STAFF REPORT: APPEAL DE NOVO COASTAL PERMIT

Appeal Number **A-3-SLO-05-017, Pine Knolls Water Tanks**

Project description Removal of two existing 103,000 gallon water tanks; construction of two new 550,000 gallon water tanks; relocation of electrical control panel and overhead electric service; replacement of 200 linear feet of waterline and valves.

ALTERNATIVE A

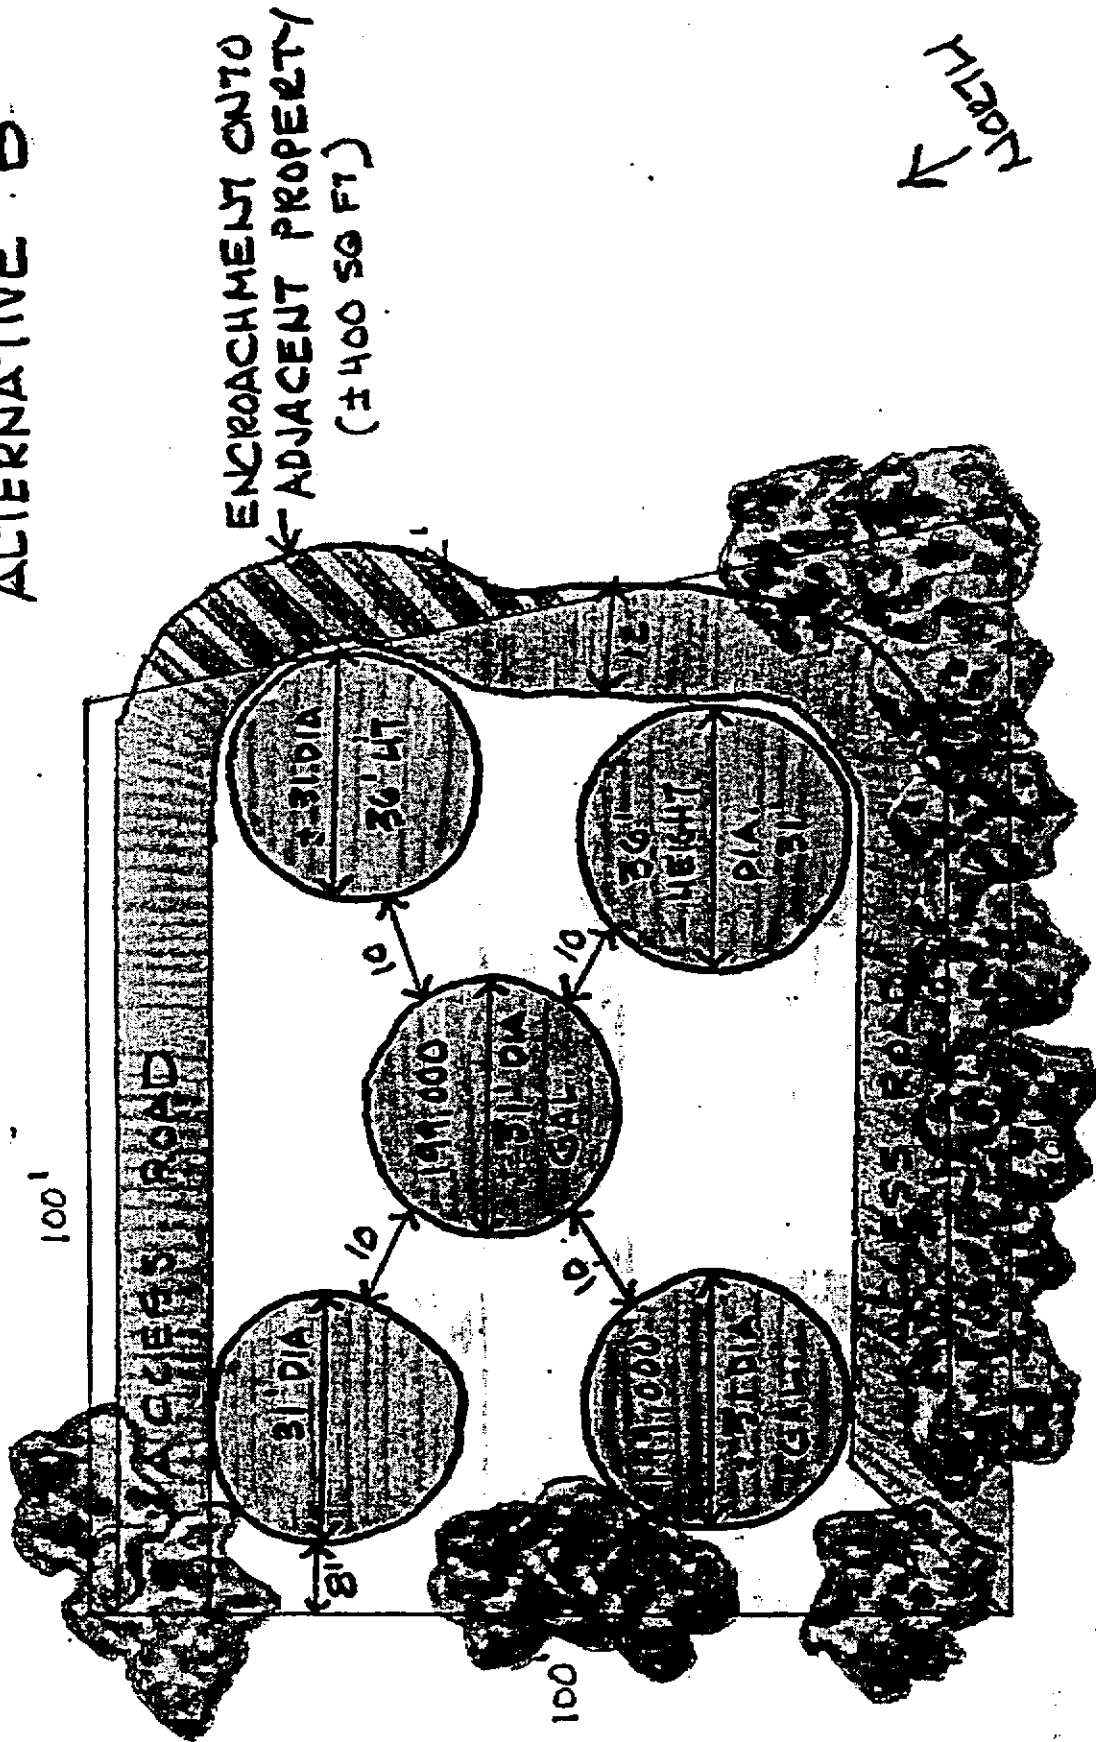
1,055,000 GALLON STORAGE
ONE 50' DIAMETER + THREE 30' DIA. TANKS

ALTERNATIVE B

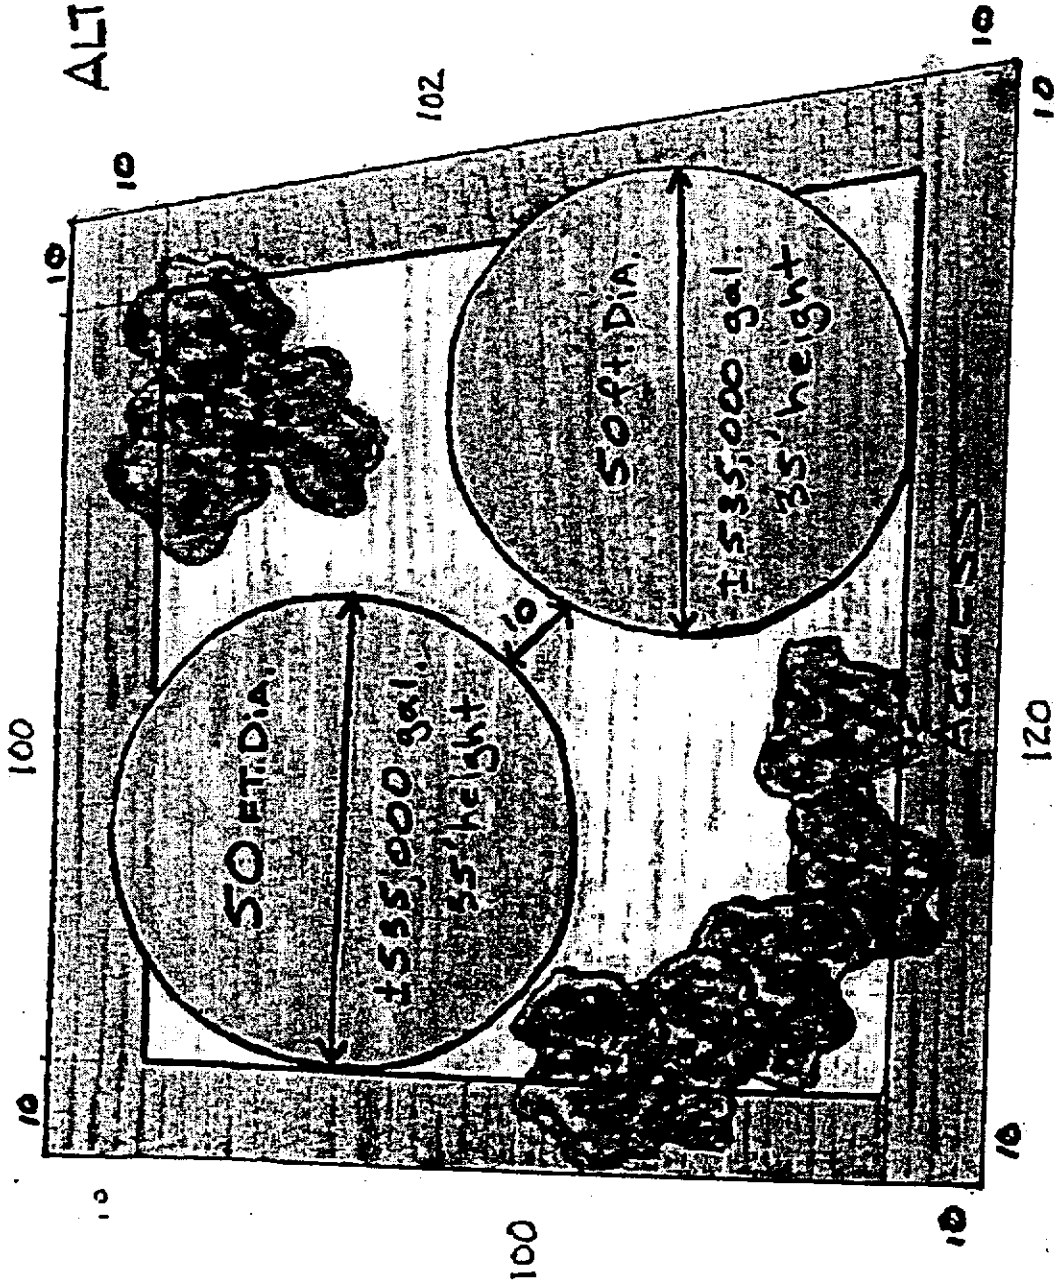
1,000,000 GALLON STORAGE ALTERNATIVE
FIVE ± 31' DIAMETER TANKS

ALTERNATIVE C

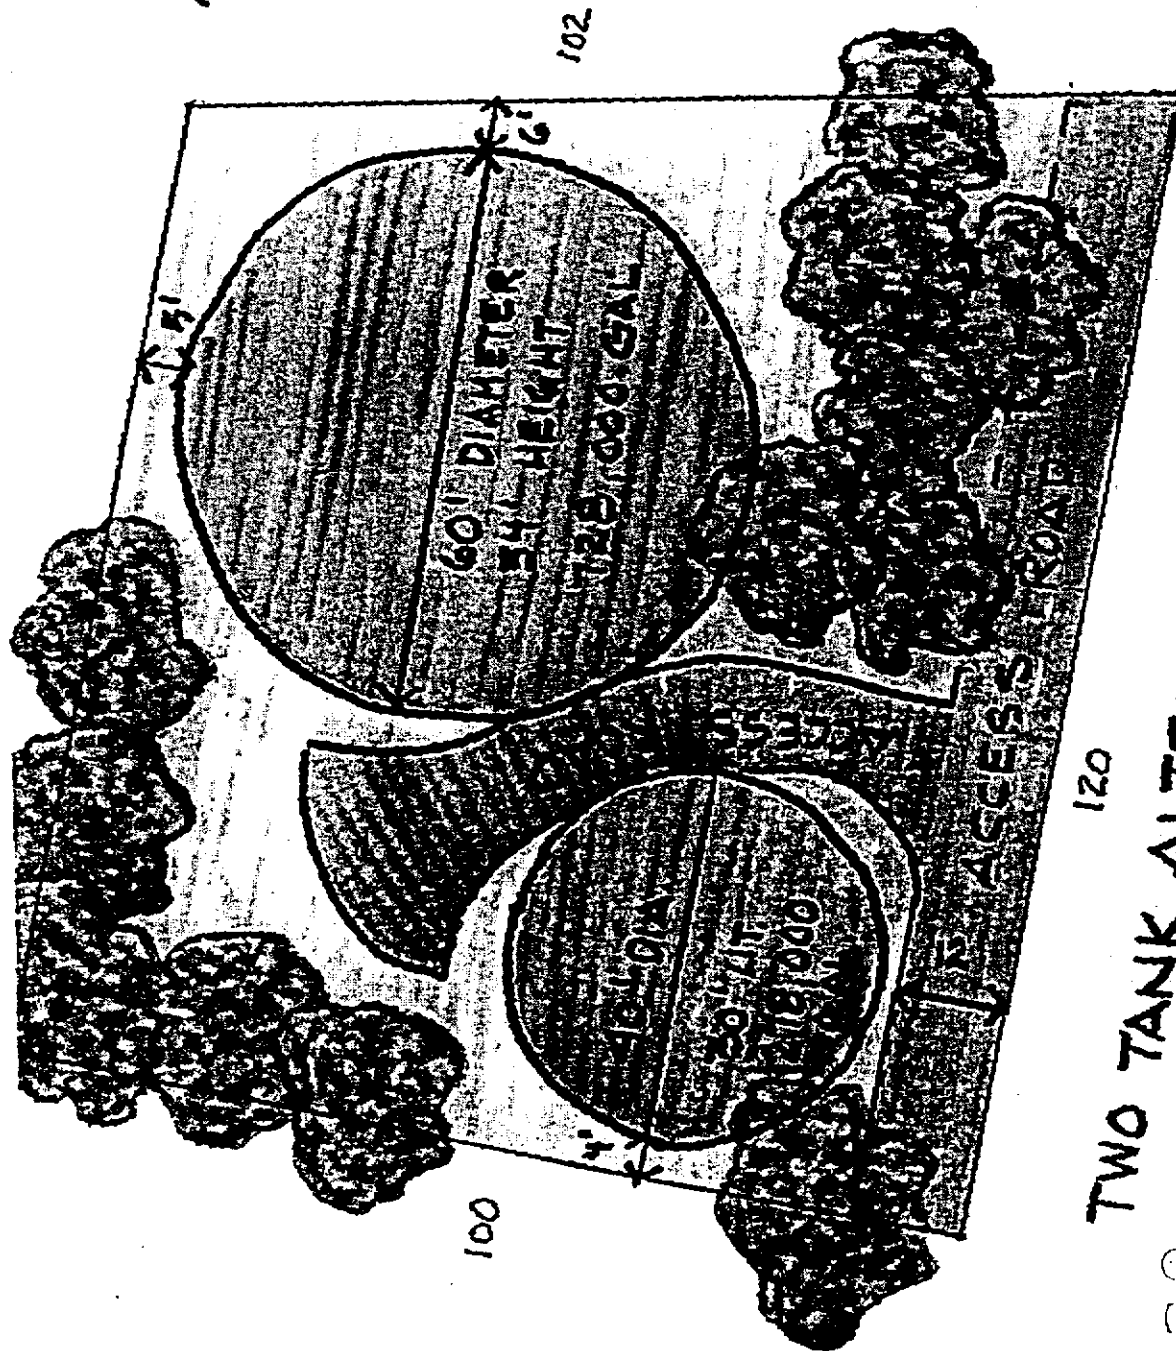
CCSD SITE ALTERNATIVE
TWO 50' TANKS
1,070,000 GALLONS STORAGE

REVISED ALTERNATIVE "B"

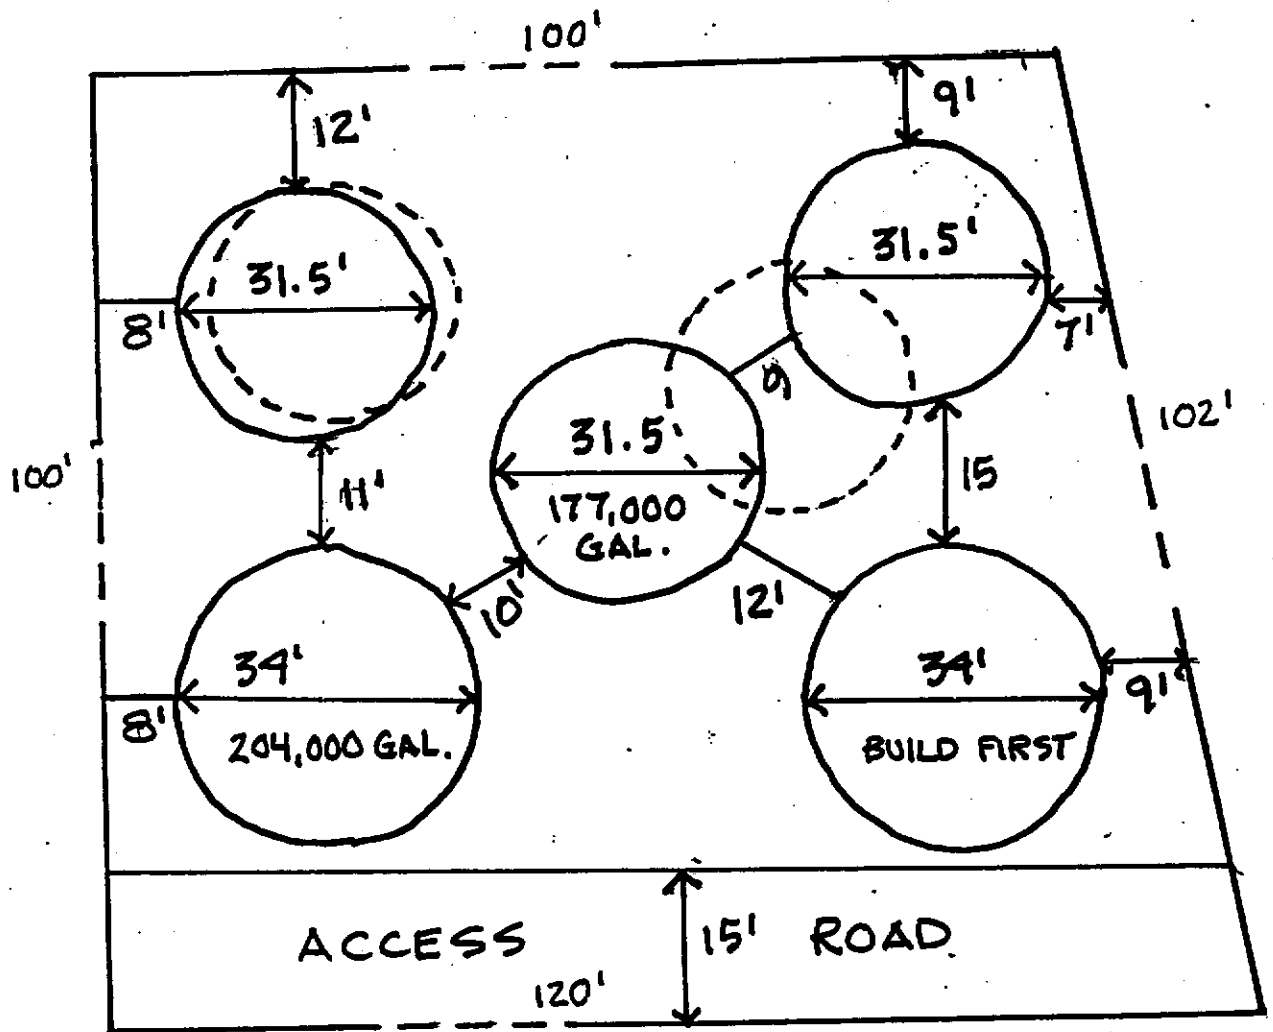
Five Tanks (all 29.5' water depth, overall height 32')

- Three 31.5' diameter tanks, 177,000 gallon capacity each
- Two 34' diameter tanks, 204,000 gallons capacity each
- Total water storage capacity 939,000 gallons

REVISED ALTERNATIVE "D"

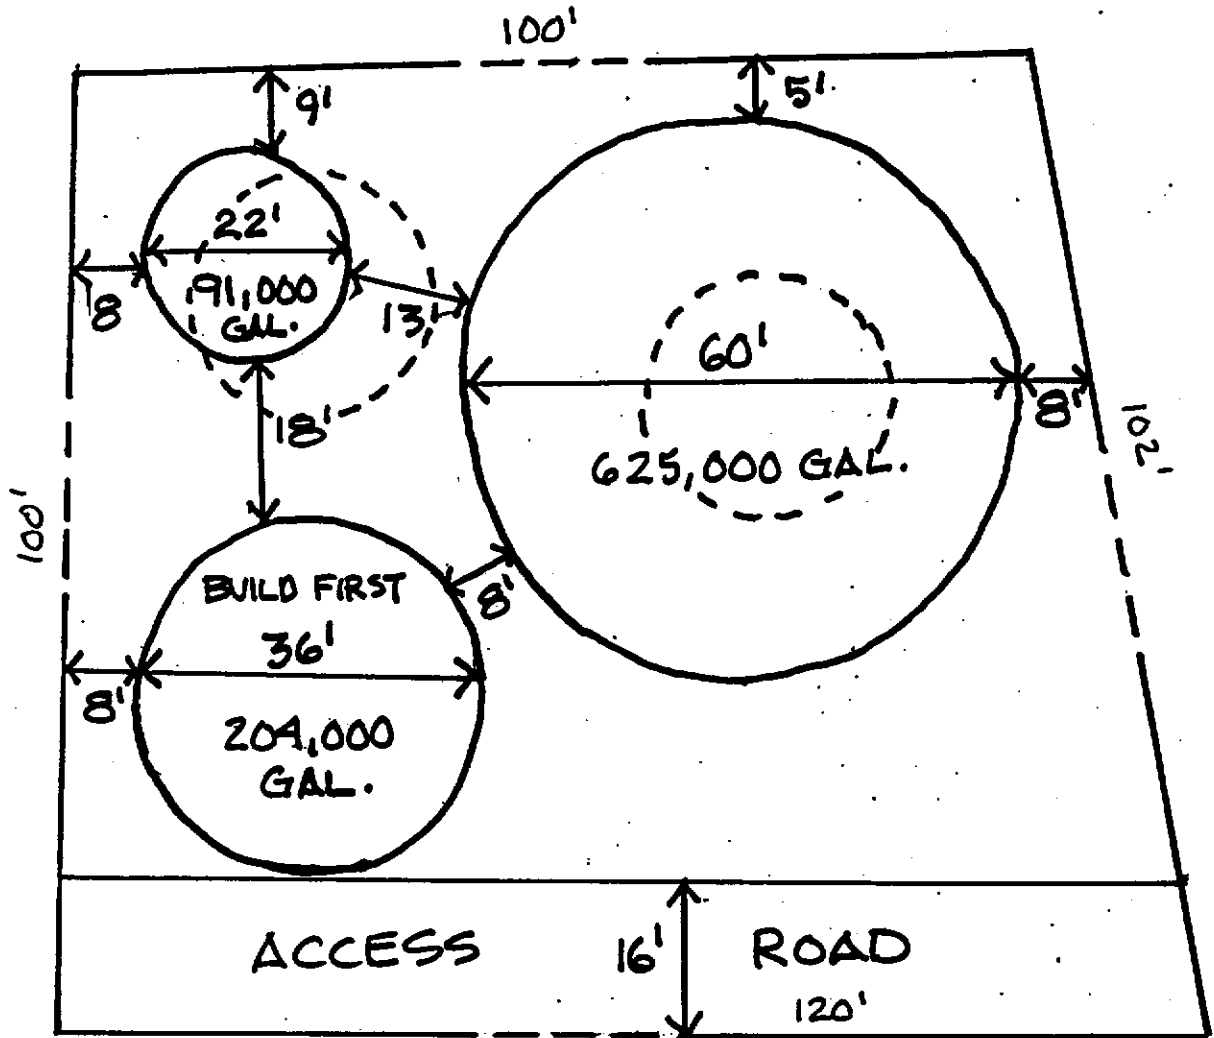
- One 60' diameter tank, 625,000 gallons capacity
- One 35' diameter tank, 204,000 gallon capacity
- One 22' diameter tank, 91,000 gallon capacity
- Total water storage capacity 920,000

REVISED ALTERNATIVE "C"

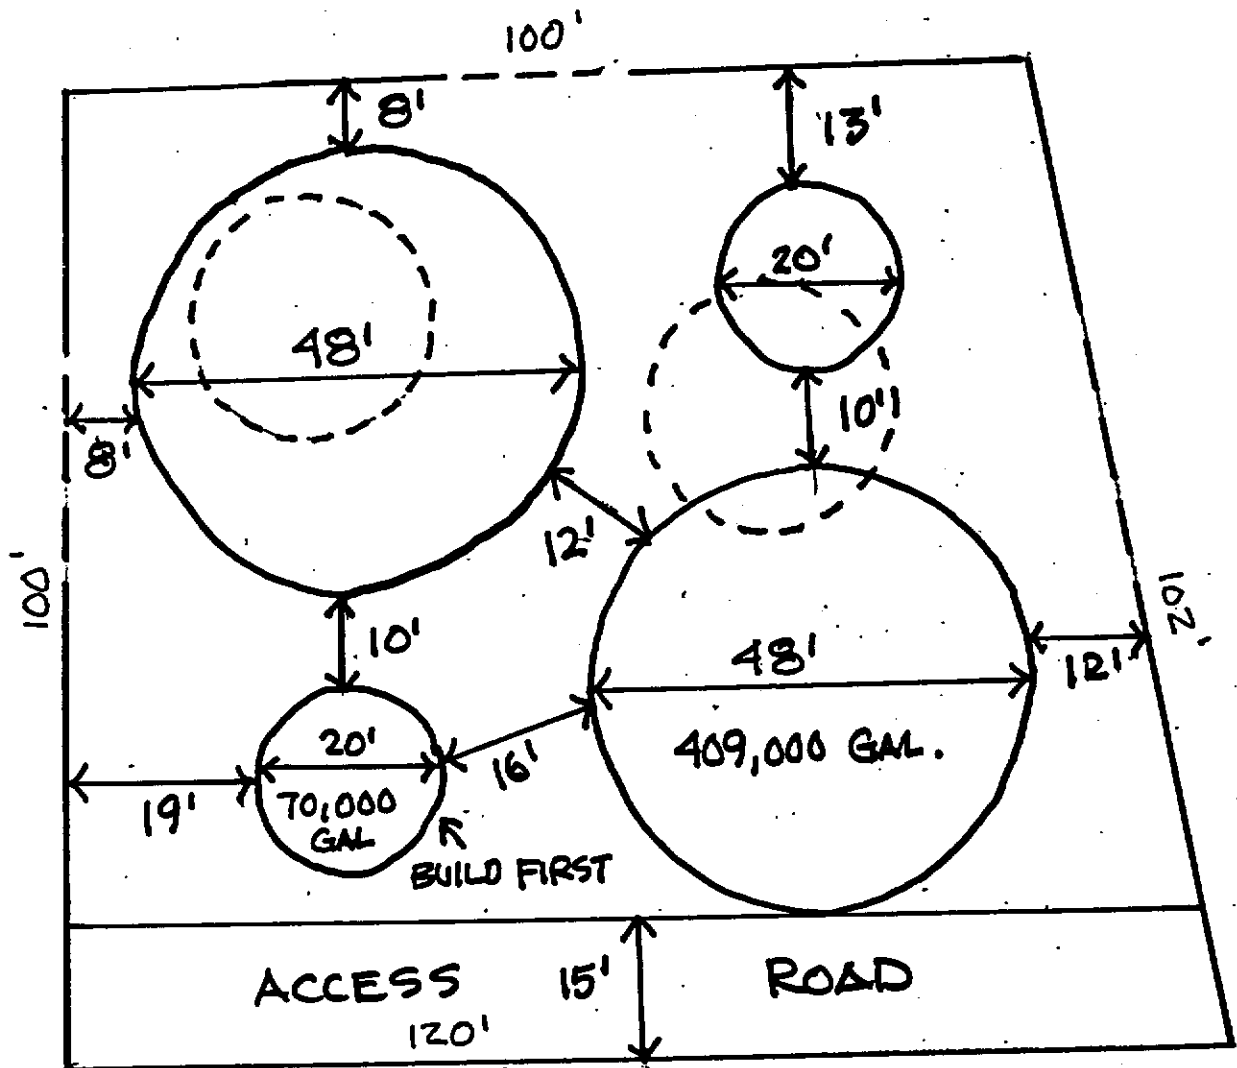
Four Tanks (all 29.5 water depth, overall height of 32')

- Two 48' diameter tanks, 409,000 gallons capacity each
- Two 20' diameter tanks, 70,000 gallons capacity each
- Total water storage capacity 958,000 gallons
